GREAT LAKES INDIAN FISH AND WILDLIFE COMMISSION

August 11, 2015

Re: Comments on PolyMet mine site contaminant northward flowpath and groundwater model calibration.

Flow of particles when P-M pits are at closure levels (457 meters).

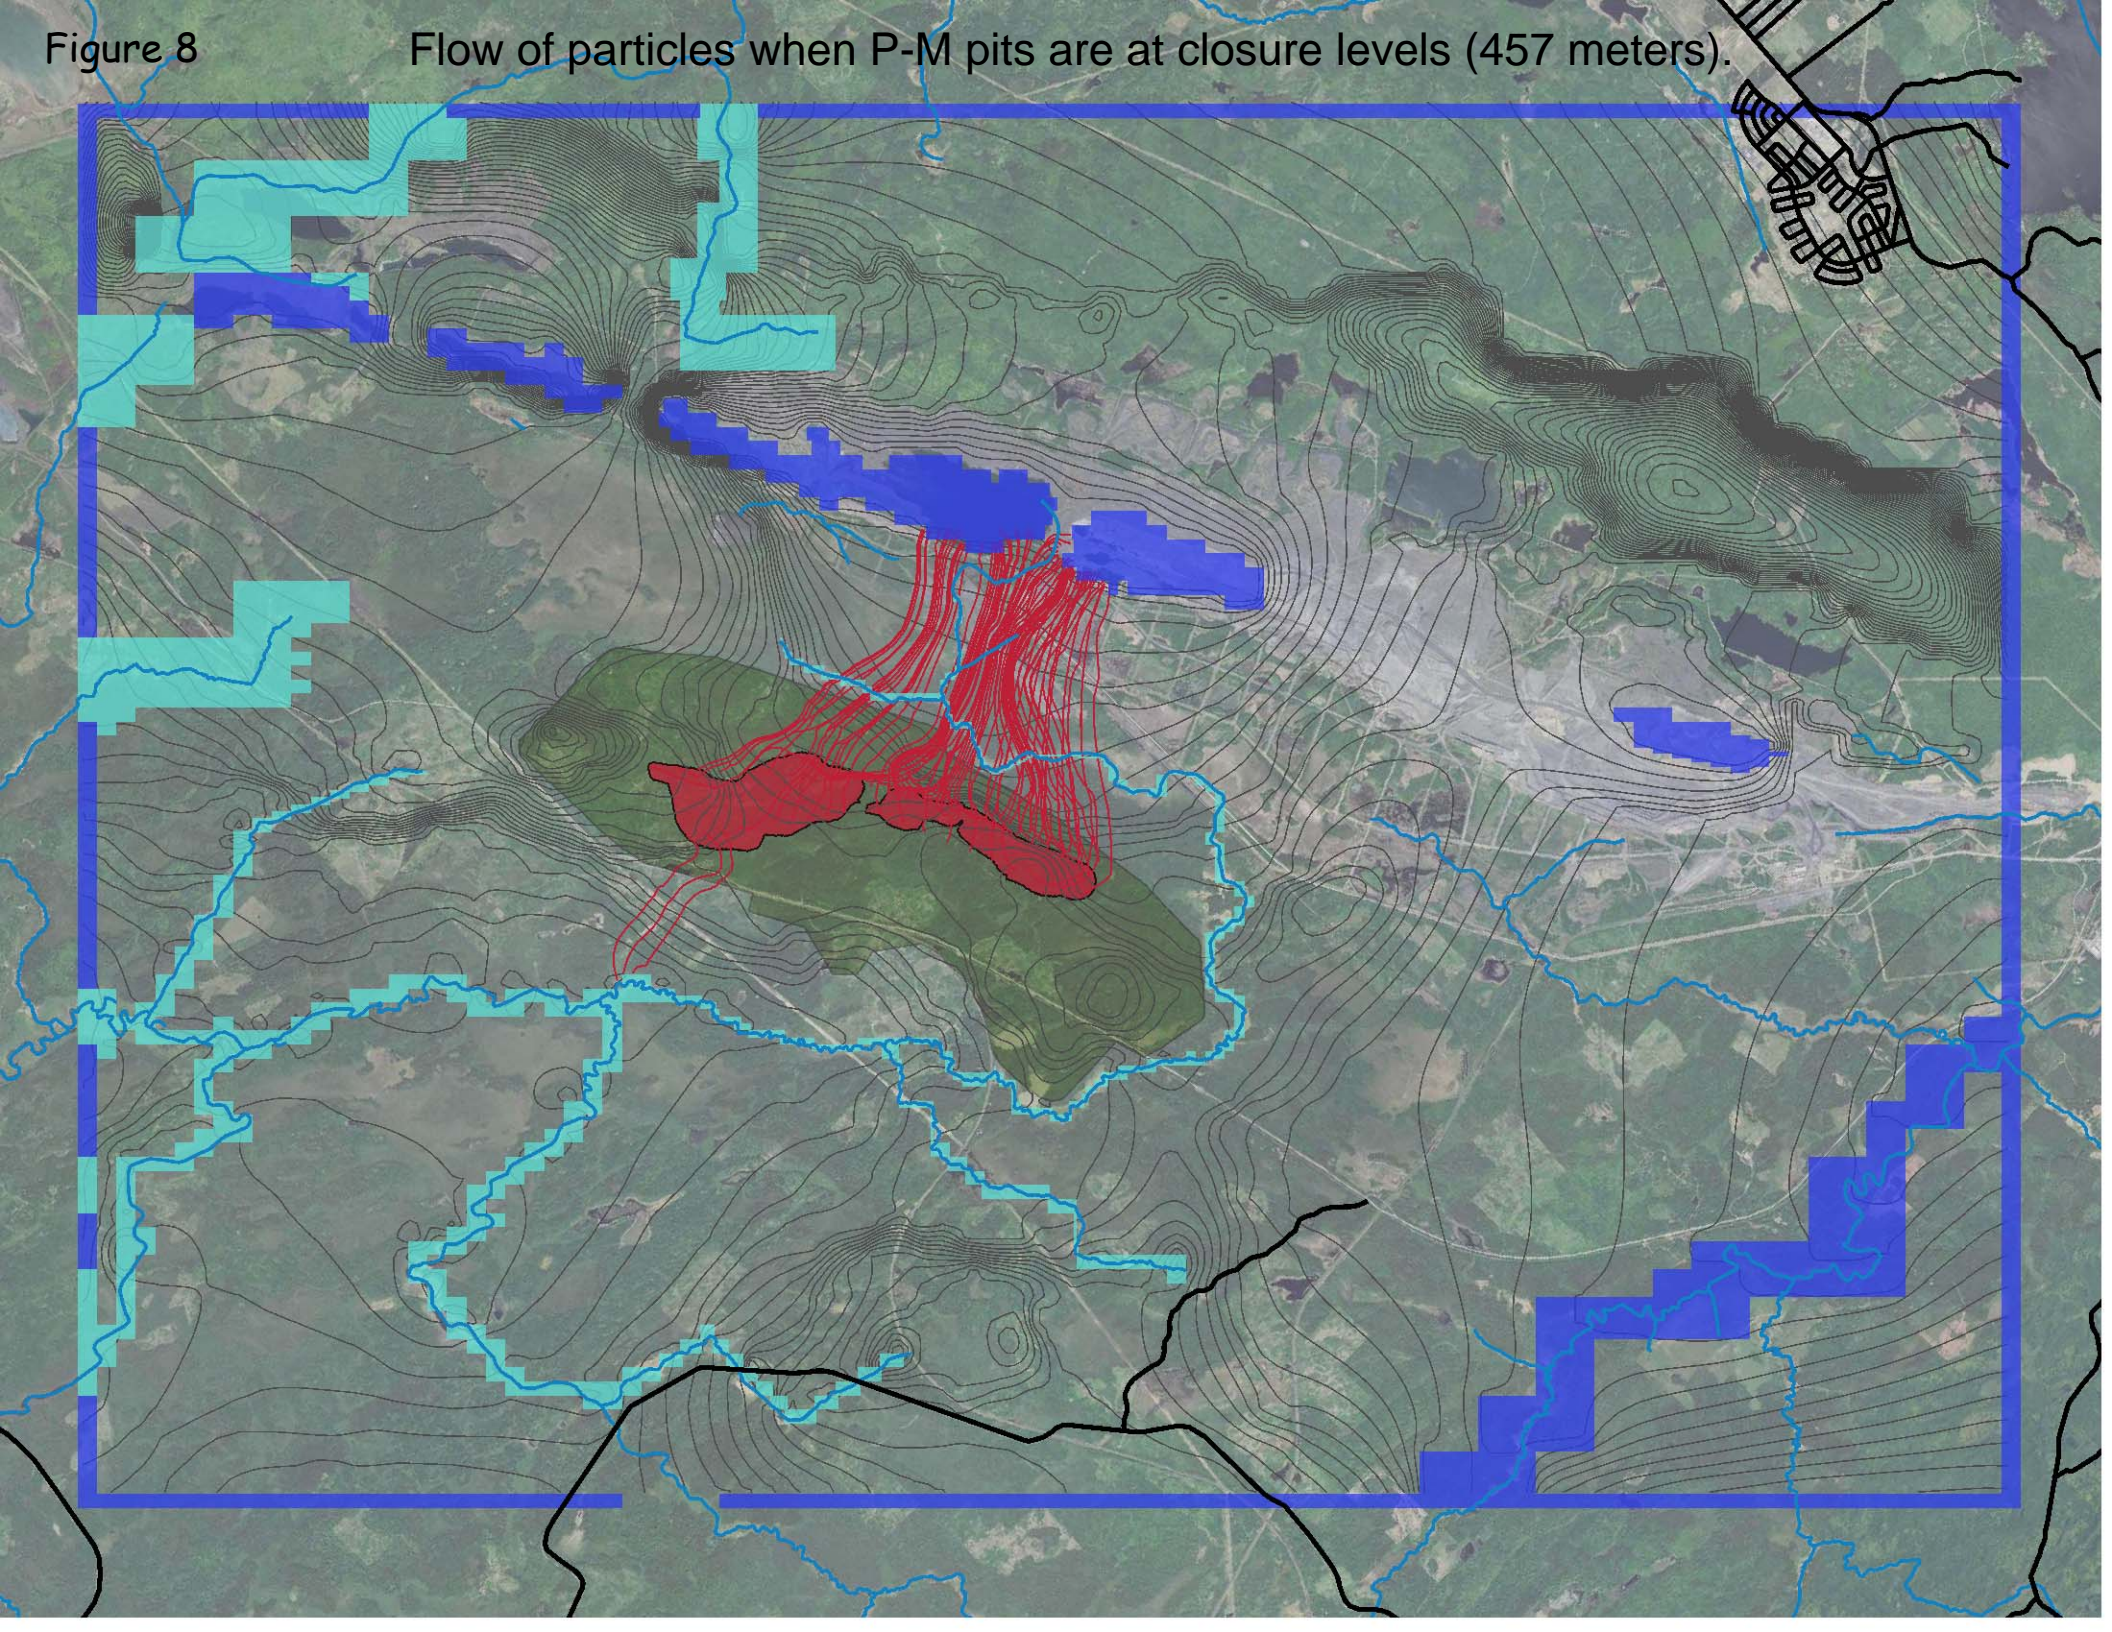
Figure 8 - A map of particles (water) moving from the Polymet pit areas to the P-M pits. This scoping level modeling used the Polymet base MODFLOW model with P-M pits set to their long-term level of 457 meters (1500 ft). Because the upper Partridge River would be unable to supply unlimited water to the aquifer, discharge from the upper Partridge River to the groundwater system is prevented in this model run.

Particles were added to the surficial aquifer and allowed to travel in the direction that the aquifer carried them. These particle tracks originate in the area of the proposed Polymet pits and end at the P-M taconite pits. A few particles leave the Polymet west pit area and travel to the Partridge River because the S-W corner of the Polymet west pit is on the south side of the watertable divide.

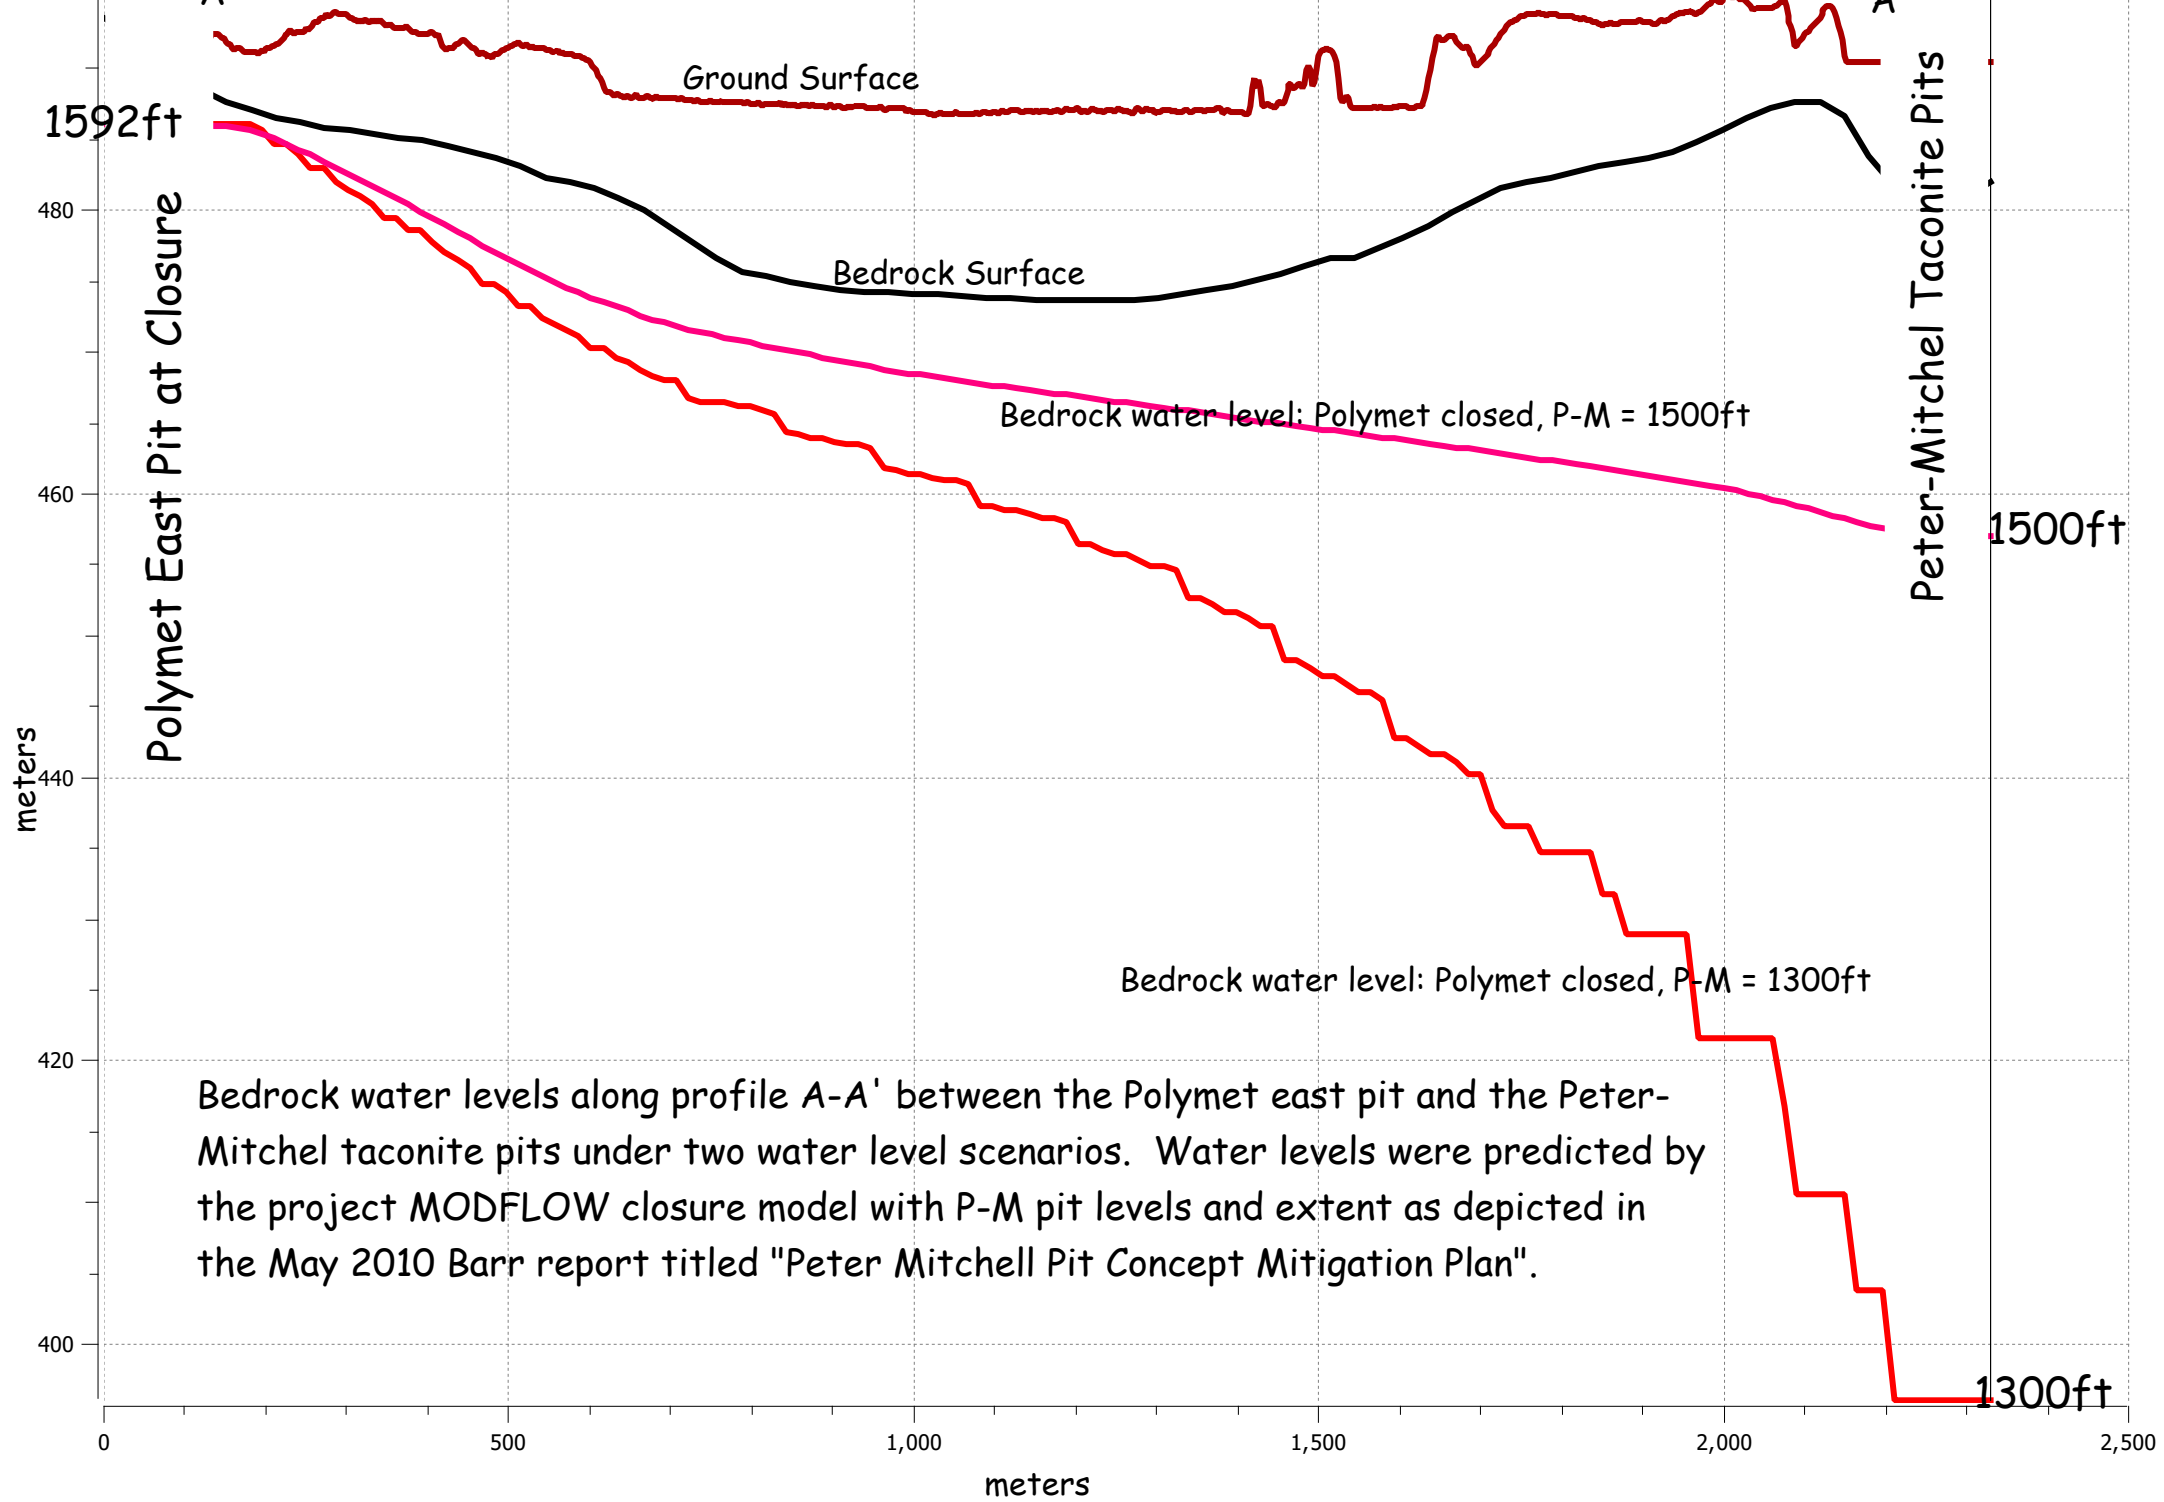
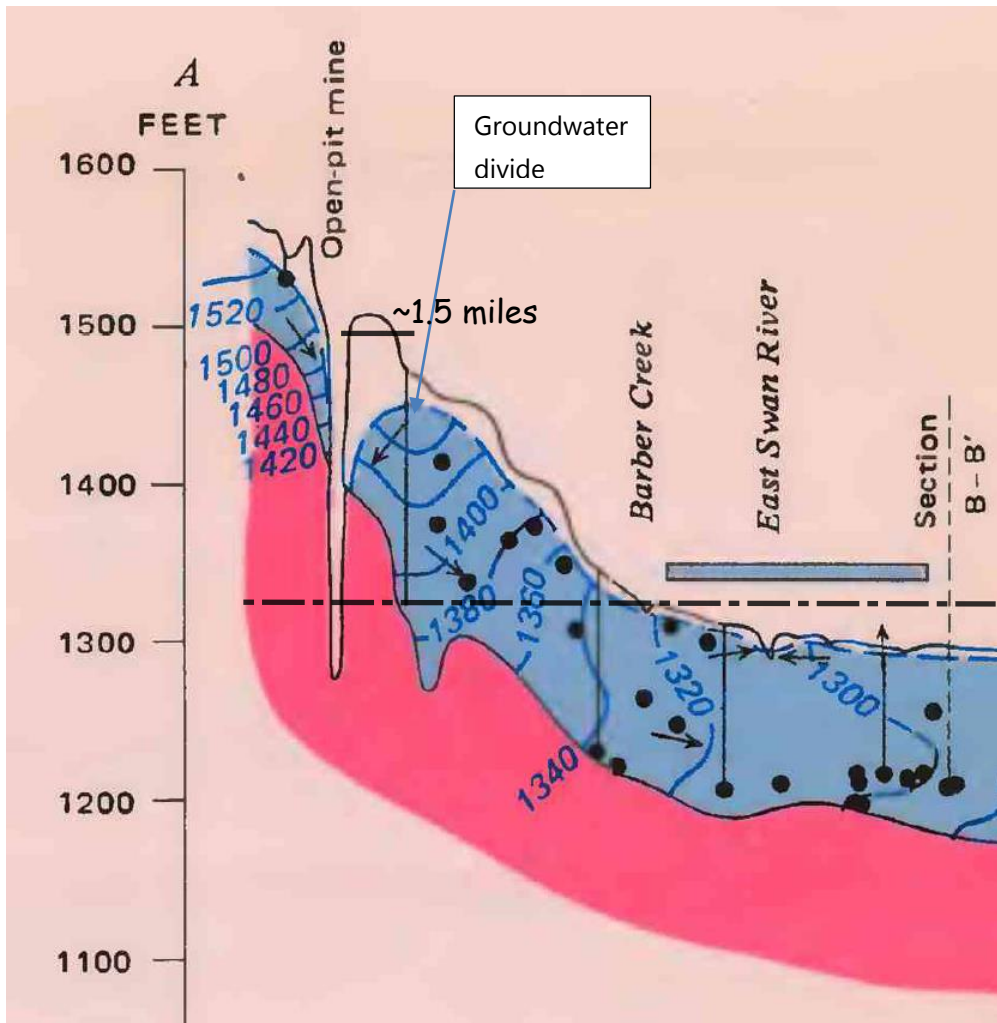
Northward flow of groundwater is in agreement with ERM's Mathcad model which shows bedrock water levels sloping steeply to the north given the water levels expected at closure of the P-M pits. According to ERM's MathCad analysis, only if a groundwater mound forms in the bedrock would flow to the north not occur (attached as Attachment B). Formation of such a substantial mound by movement of water downward from the 100 Mile Swamp is simply not possible given the hydrogeology defined by project documents (e.g. WMDPv13 Table 3-4, attached as Table 2).

The result, from both the project MODFLOW model runs with the correct closure water elevations and ERM's MathCad model runs, indicate that water in bedrock will flow to the north from the PolyMet site at closure, unless a bedrock groundwater mound forms. No feasible natural mechanism for such a mound has been articulated. A bedrock groundwater mound at the level necessary to prevent northward flow, i.e. a mound of elevation of approximately 1600 feet, appears to be hydrologically impossible without long-term active management. Northward flow would be primarily from the PolyMet east pit and, despite attempted containment in the surficial aquifer, from the Category 1 stockpile. These flowpaths have been overlooked in project evaluations of contaminant transport. The current project contaminant transport modeling, which assumes contaminant flow paths only to the south and south-east, is incomplete because it is based on the incorrect assumption of 1996 era water levels in the taconite pits, even during closure, a water level that is more than 300 feet too high.
